AR-07-1162

Southern Nuclear Operating Company
Vogtle Early Site Permit Application
Supplemental Response to Requests for Additional Information on Geology/Seismology

Supplemental Response to Geology/Seismology RAIs

Vogtle ESP Application

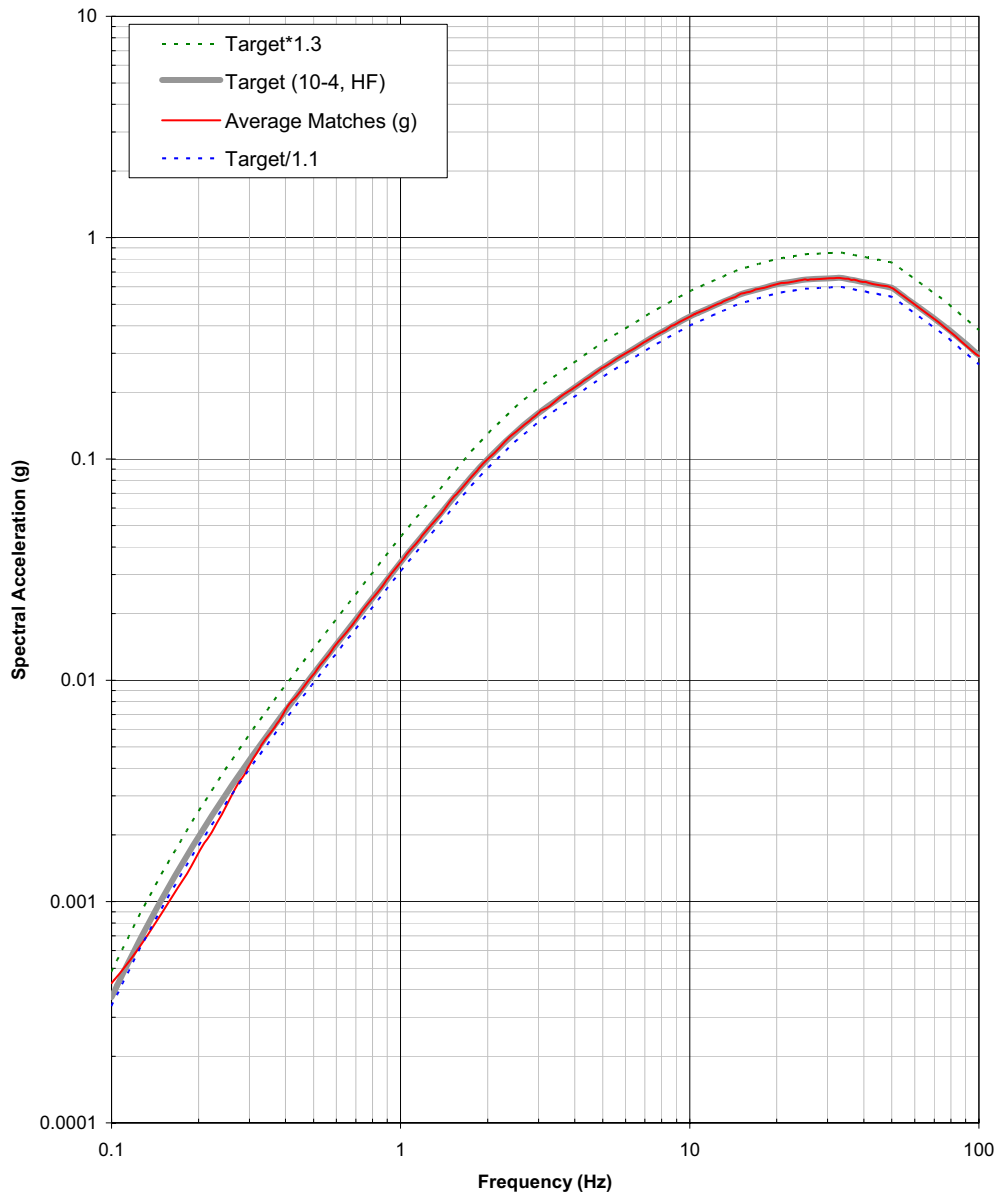
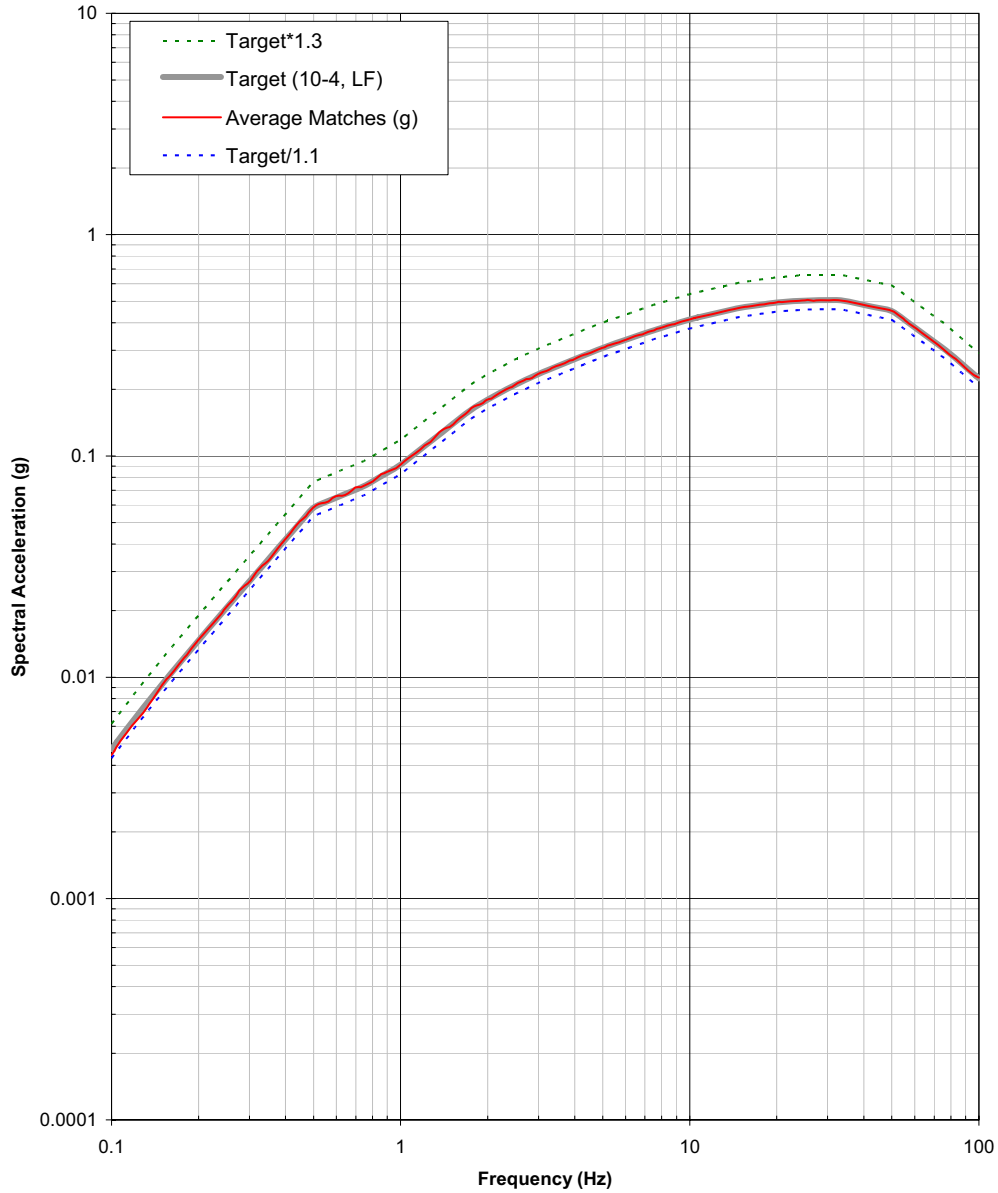
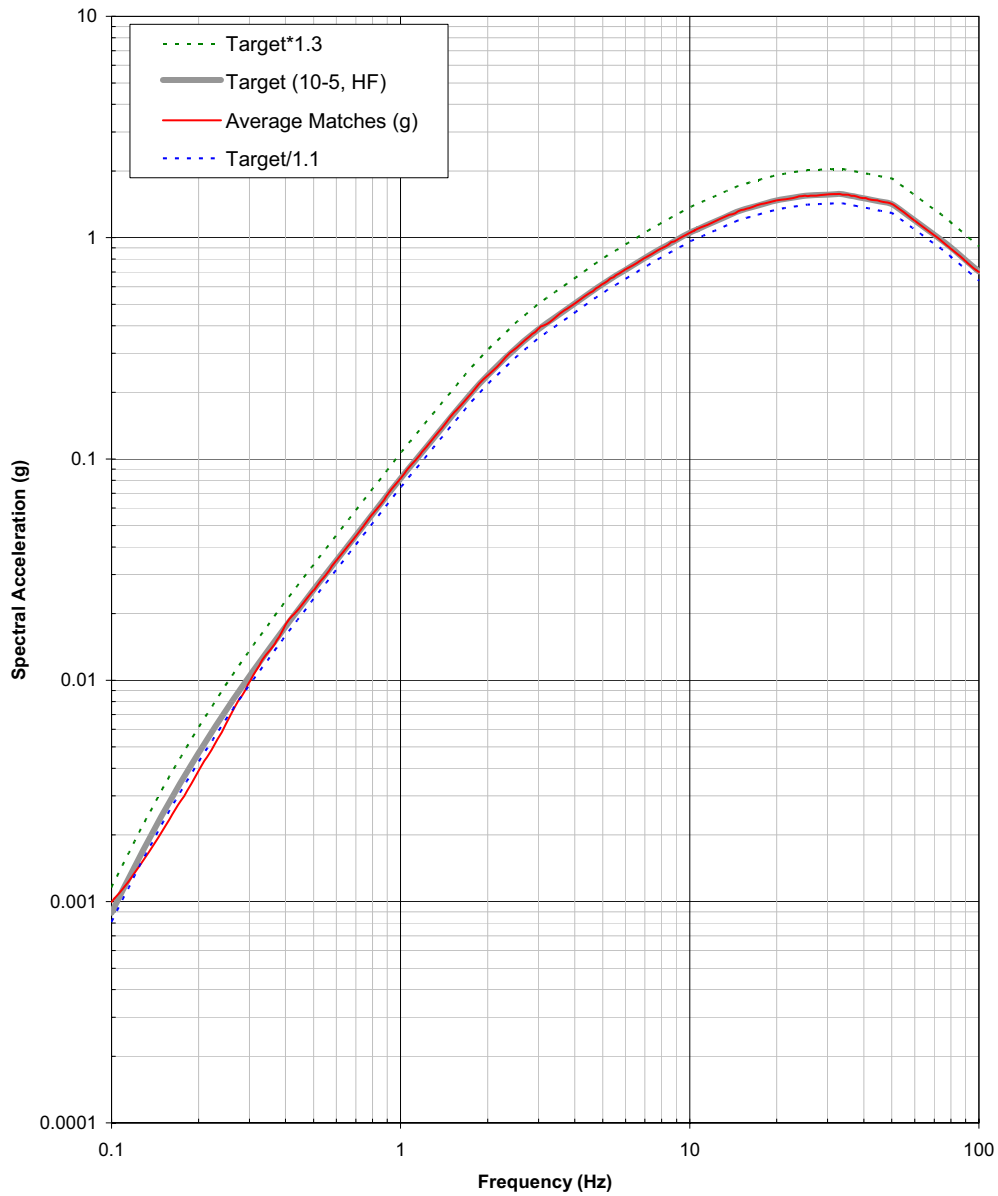
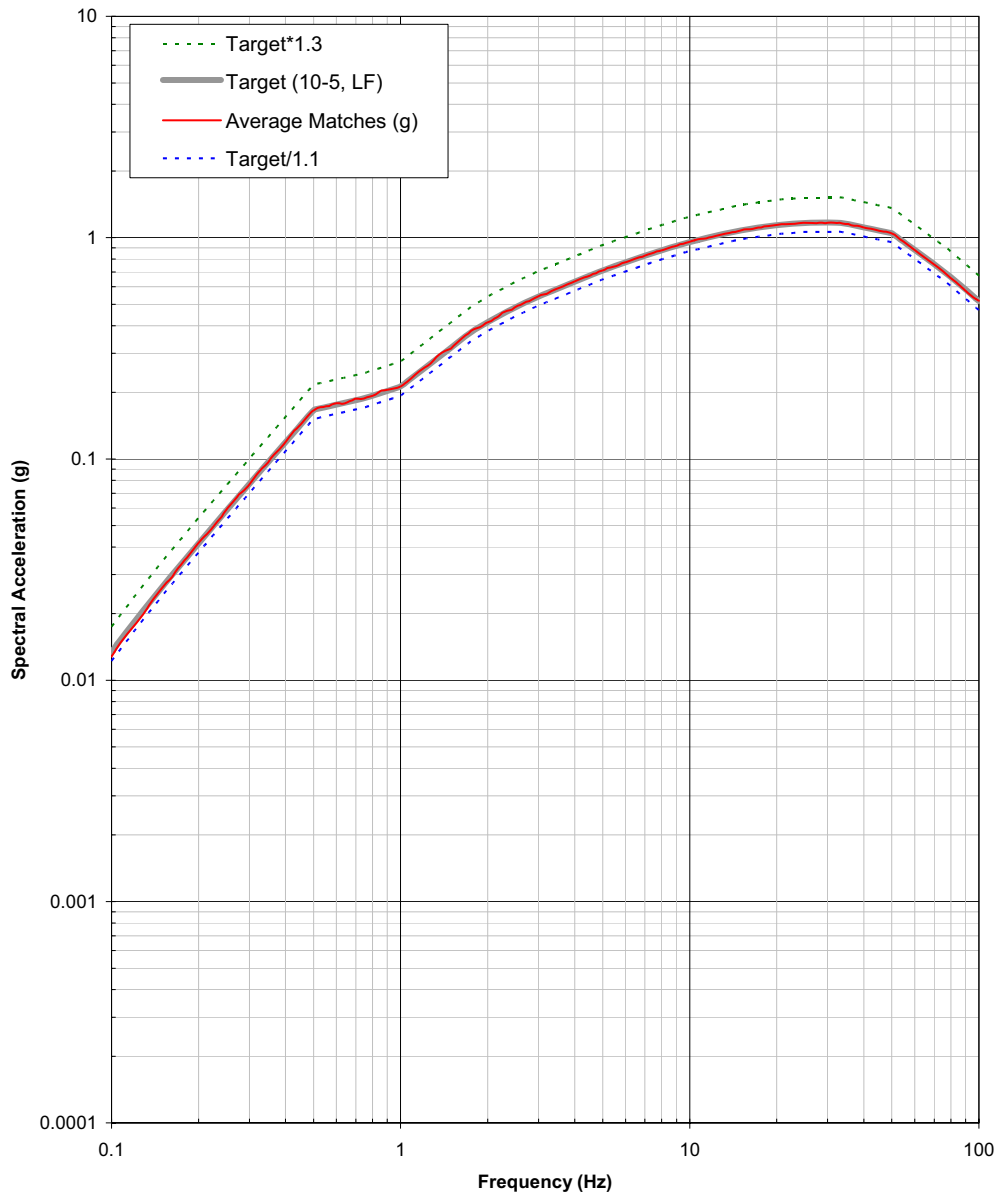
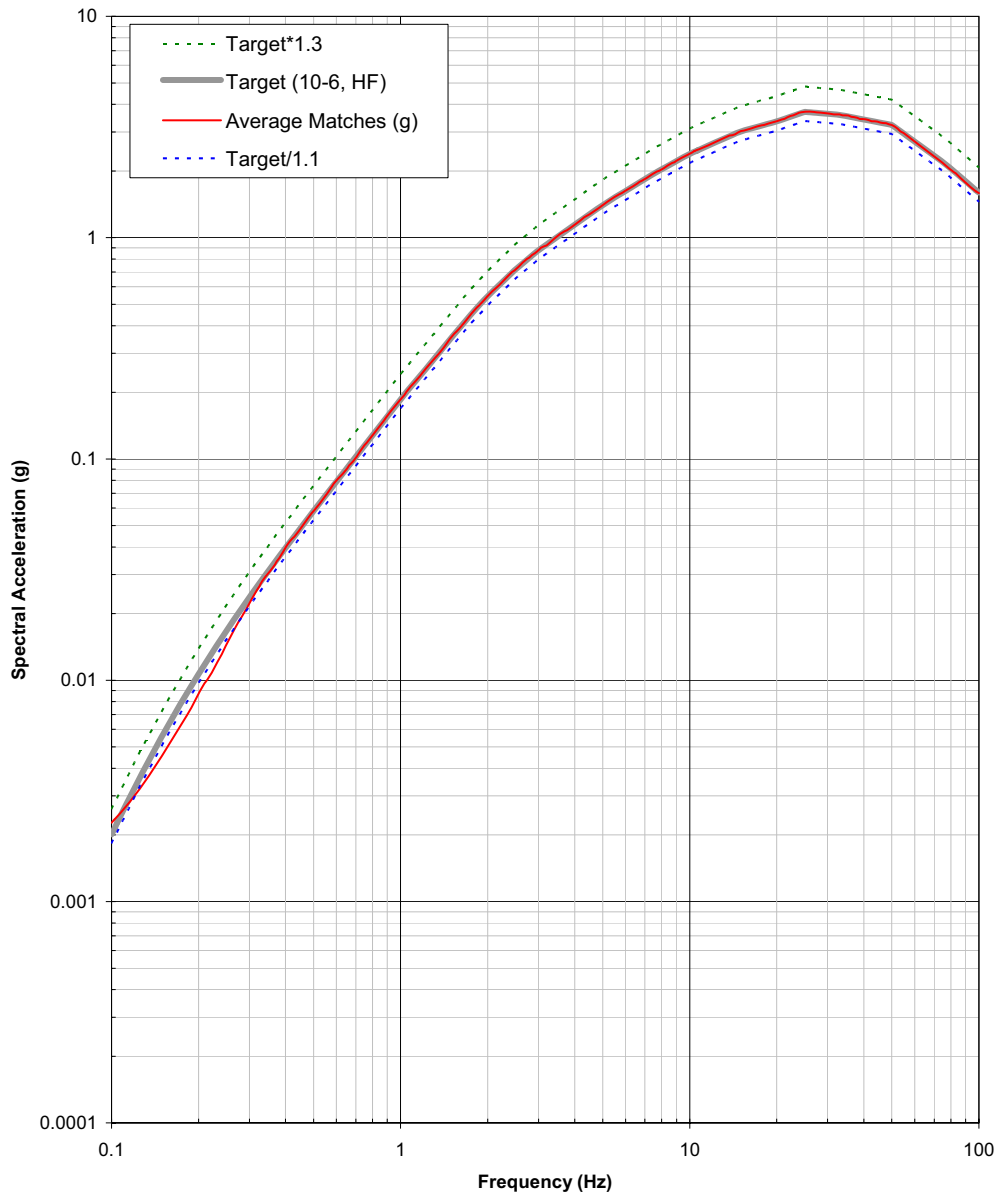
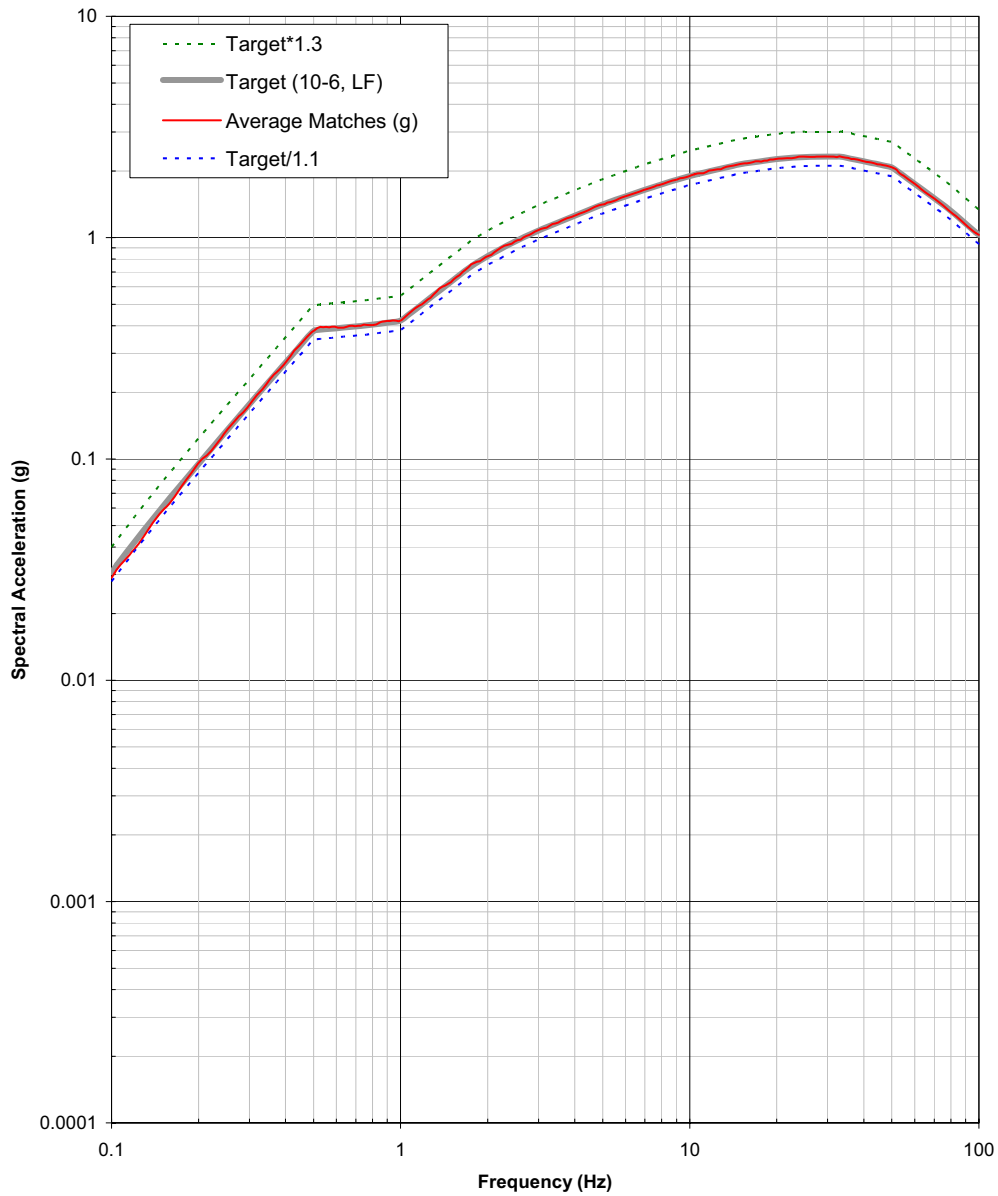
Please explain whether the additional criteria listed in NUREG/CR-6728 were also satisfied. If these additional criteria were not satisfied, please provide justification for not doing so.

For the site response analysis, 30 acceleration horizontal time histories were modified to be spectrum compatible to given target spectra. Target spectra were developed for both the high- and low-frequency cases at each of the three annual probability levels: 1×10^{-4} , 1×10^{-5} , and 1×10^{-6} . This resulted in a total of 180 spectrum compatible acceleration time histories for the site response analysis. For a given suite of 30 time histories, the spectral matching criteria given in NUREG CR-6728 were used as guidance.

As specified in the NUREG CR-6728 spectral matching criteria, when using multiple sets of time histories, the mean (linear average) of the 5% damped response spectra (in this case for a given suite of 30 matches) can be used in place of the individual 5% damped response spectra for checking against the target response spectra. Criteria (a), (d), and (e) define the matching requirements for the mean response spectra and the given target response spectra. These criteria are defined for the frequency range of 0.2 to 25 Hz. For the three low frequency cases (i.e., 10^{-4} , 10^{-5} , and 10^{-6}) the mean of the suite of spectrum
